Design Advice Request

SUMMARY MEMO

Re: EA 22-153871 DAR – 205 NE Russell/216 NE Knott | Albina Library

Design Advice Request Commission Summary Memo - August 8, 2022

N/S Building Section

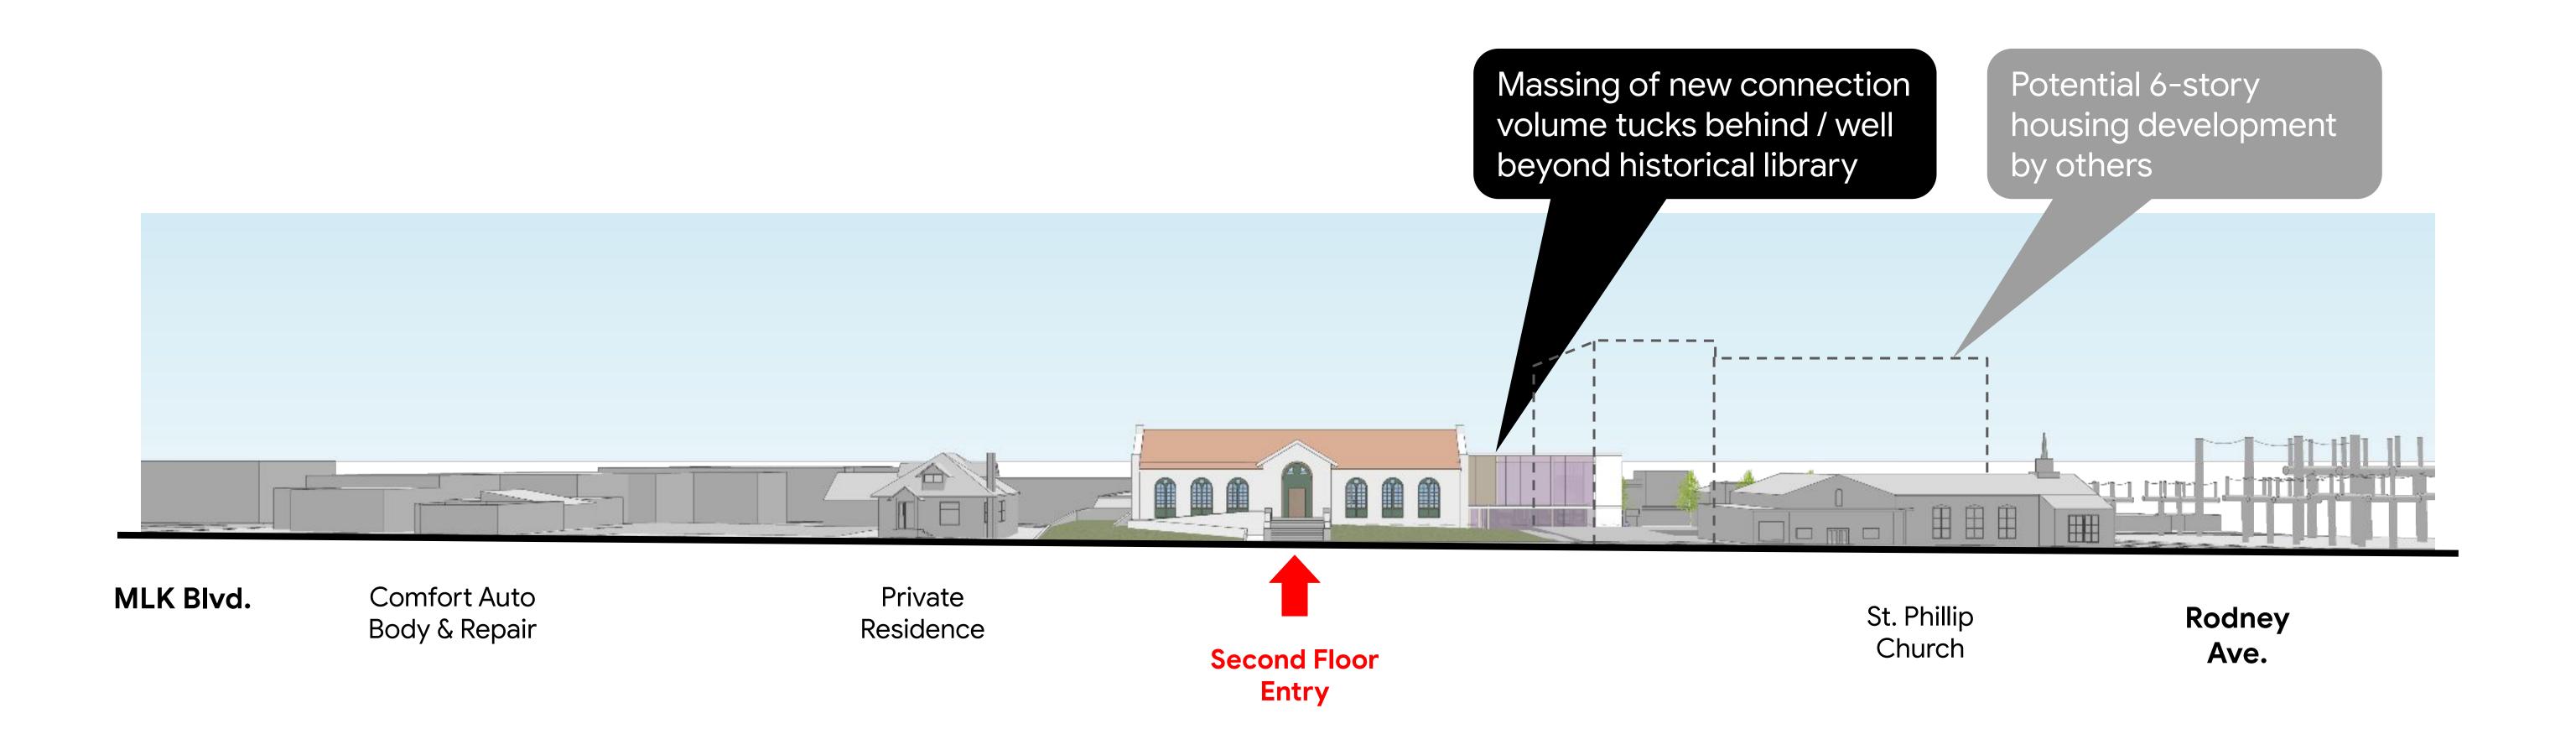
One Commissioner noted that the general massing works but noted some confusion in the drawings. Specifically, she noted that the second story height viewed from the north will perhaps be more pronounced than the graphics show (since the roof is angled, the height will vary depending on where the section is cut). The one graphic on page 37 shows the elevation of the new addition viewed from the north at a lower height than the section shows it.

Context:

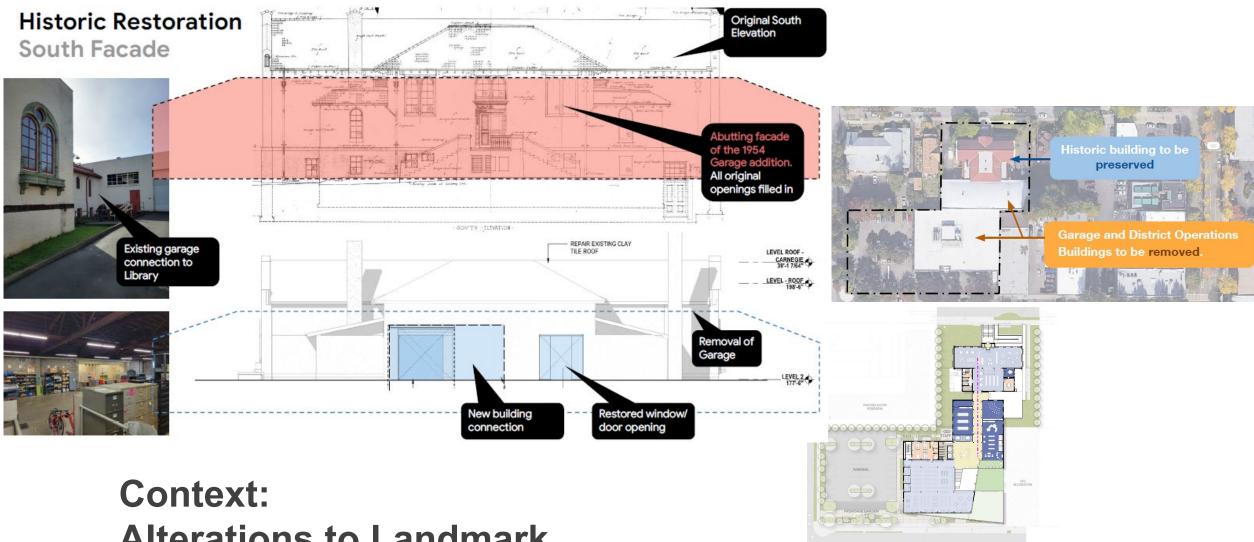
Unclear how the addition is compatible with regard to form, fenestration pattern, materials, etc.

Proposed South Facade

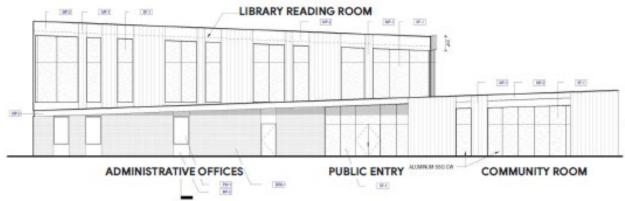
Alterations to Landmark

- Minimizes connection point to landmark
- Unclear about alterations at rear façade of landmark

Context: Modifications Required

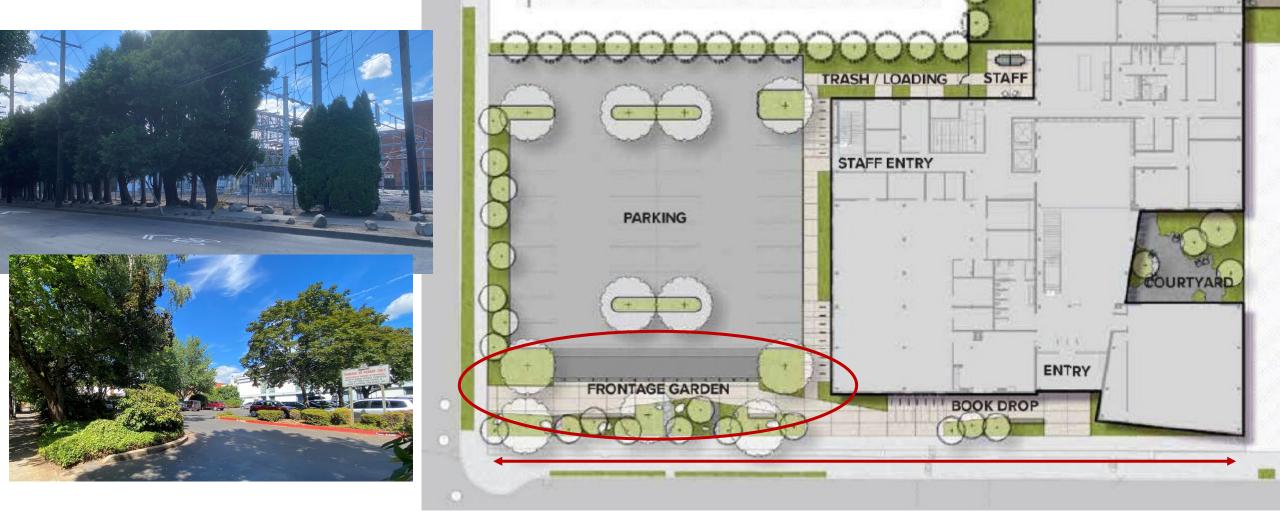
- Maximum Setback
- Ground Floor Windows
- Frontage Limitation
- Interior Parking Lot Landscaping
- Loading Size

Edges along Surface Parking Lot

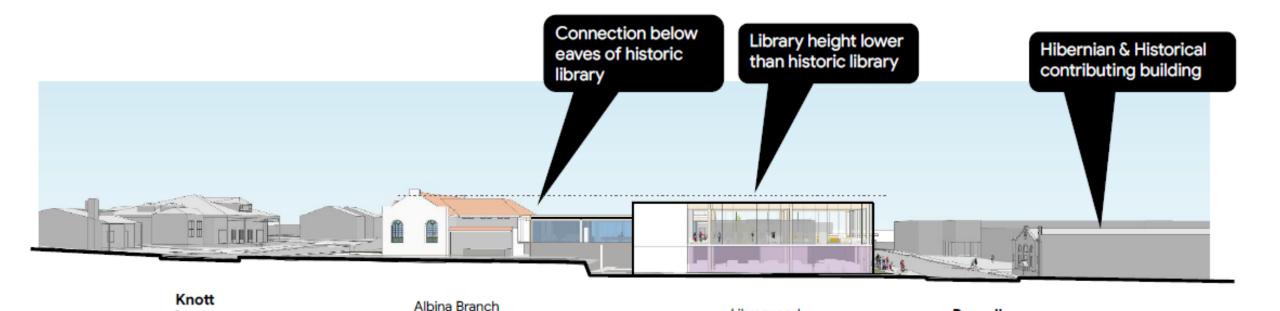
- Concerns with secondary sidewalk
- NE Rodney already challenged
